Access Compliance Report

Public Rights-of-Way

Intersection ID: 8626	Main Street: TRYON ST	Cross Street: NORTHCHASE DR	Location: S
ADA ID: 62B7AED7C6AF	Ramp Type: BlendTrans1	Initial Pass/Fail: Fail	Overall Compliance: No
		Severity Score: 15

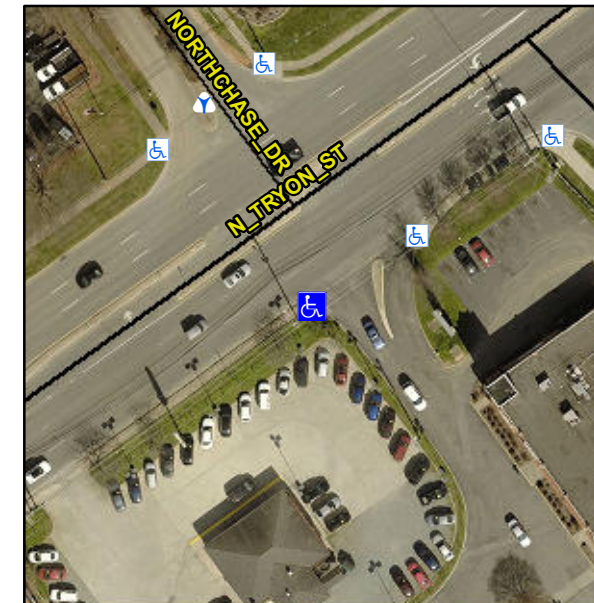
MEDIAN ACROSS TRYON ST

R302.7

Remove & Replace Curb Ramp With Two New Directional Ramps or Equivalent.
